## Stirling to Crafers Bikeway Proposal

Bike Adelaide (formerly the Bicycle Institute of SA) is very supportive of this project to link Crafers and Stirling with a safe cycling route. We congratulate both Council and the consultants for the work to date. We understand that the plans provided for our comment are not a detailed design but provide our detailed feedback to assist in the following phase.

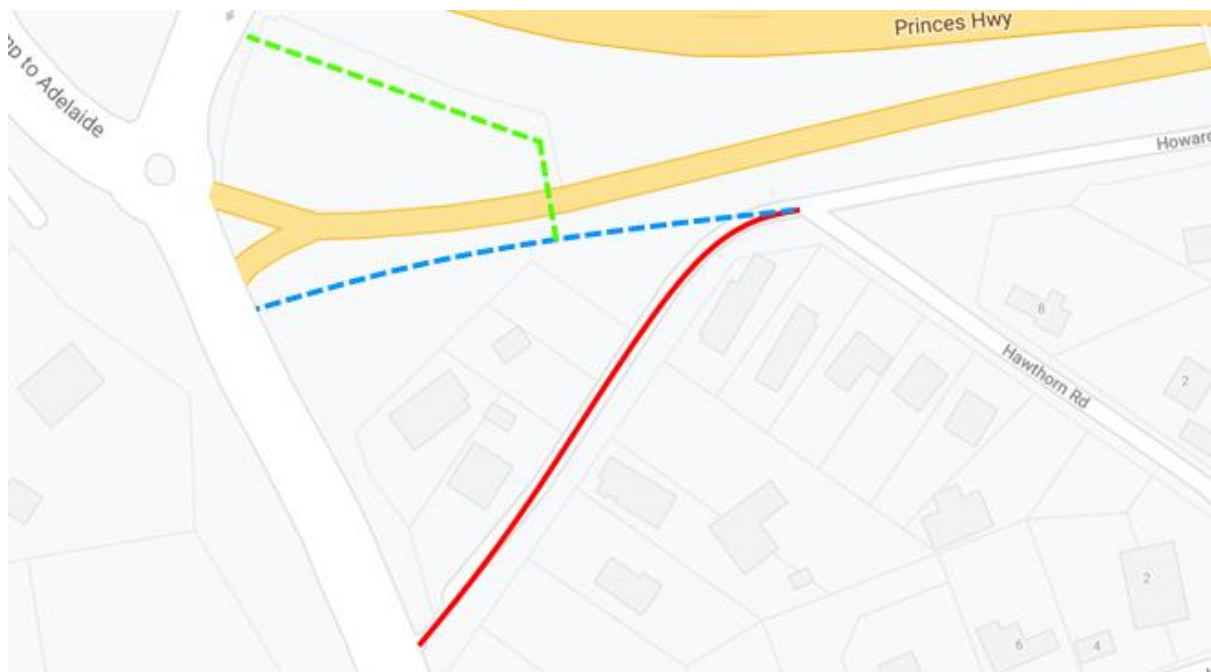
Given a lower speed environment for Main Street Crafers, we would like to see the roundabout at Main Street Crafers/Mt Lofty Summit Road redesigned from a tangential design base to a radial design base. Radial design has been demonstrated to be safer for cyclists.

This is also desirable for the roundabout at Waverly Ridge Road/Crafers Interchange ramp, on the southern side of the freeway; and the end of the route at Avenue Road in Stirling.

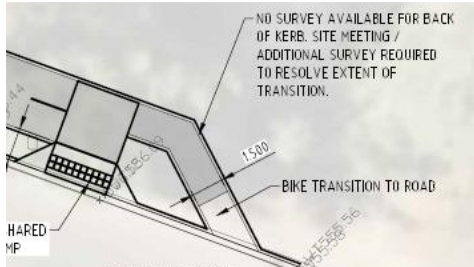
The use of Waverley Court as part of the concept layouts (red route in the diagram following) introduces a number of compromises for cyclists. The greatest of these is that it is a detour along Waverley Ridge Road and back up along Waverley Court. This is some 280m, compared to 155m for a route on the southern side of the slip lane from the Princes Highway (dashed blue line in the diagram). This extra distance also incorporates a grade climb.

Other implications are shown in [Sheet 4](#) in particular: the path/s provided cannot be maintained at 3.0m in width, with a 1.8m path used to access Waverley Court off Waverley Ridge Road. (See [Sheet 4](#) comments). This is a significant constraint in terms of the quality of the facility provided, especially coming on top of constraints imposed by the bridge crossing of the Princes Highway.

A more direct route still could be provided by crossing the slip lane from the Princes Highway at a location with good visibility and as an alternative to two crossing points at Waverley Ridge Road (green route). Pros and cons are arguable with this option, in regard to safety.

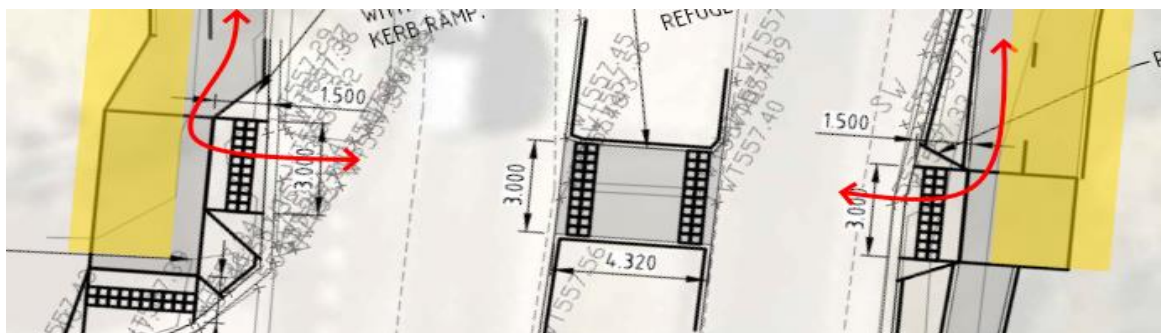
- c) Roundabout path connections should link at least to the back of the kerb ramp and desirably be set some 0.5m back from the back of the kerb ramp, with at least a 6m transition to this point.

As shown in the following diagram (at left, red line = travel line), a path that connects more suddenly into the side of the kerb ramp creates a tight, compound travel line for cyclists travelling on the inside curve. Locating the path in the yellow area, with a radius from the kerb ramp wing, would give a much better travel line.

Even where the path connects to the rear of the kerb ramp, a cyclist on the inner curve is following quite a tight turn (as in the diagram at the right side; red line = travel line).

A tight travel line is taxing/difficult for cyclists, and also makes it harder for a cyclist to be properly aligned at the kerb to be able to look for and yield to traffic. This is not conducive to cyclist safety. The Austroads Guide for paths advises that the minimum radius of curvature for cyclist paths is 2.0m. Locating the path some 0.5m from the kerb ramp (as per the yellow area) would enable this radius to be provided, including enabling an inside curve radius to be provided from the kerb ramp wing rather than the un-radiused, 'square' connection that occurs when the path connects to the kerb ramp at its side or immediate rear.

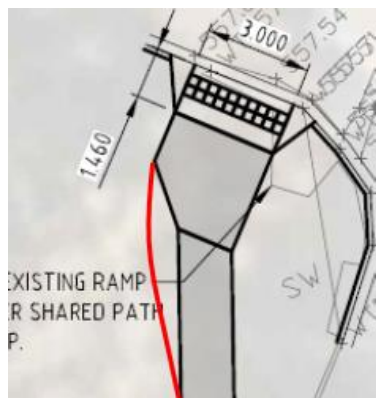
- d) Path transition, western side – We would like to see a smoother transition from the shared path width to the footpath width, to help facilitate passing if required.

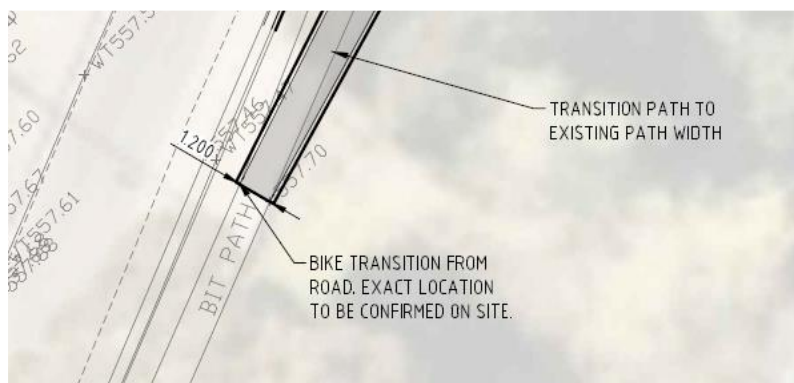
- e) Path width, eastern side – Rather than transitioning to the existing path width (apparently 1.2m), we suggest widening this section of path as much as possible, noting that the continuation on Sheet 2 is 1.5m wide. While 1.5m is narrow for shared use, this is acceptable for one-way travel given a bike lane exists on the other side of the kerb, and given that a path separated from the road is necessary to cater for children.
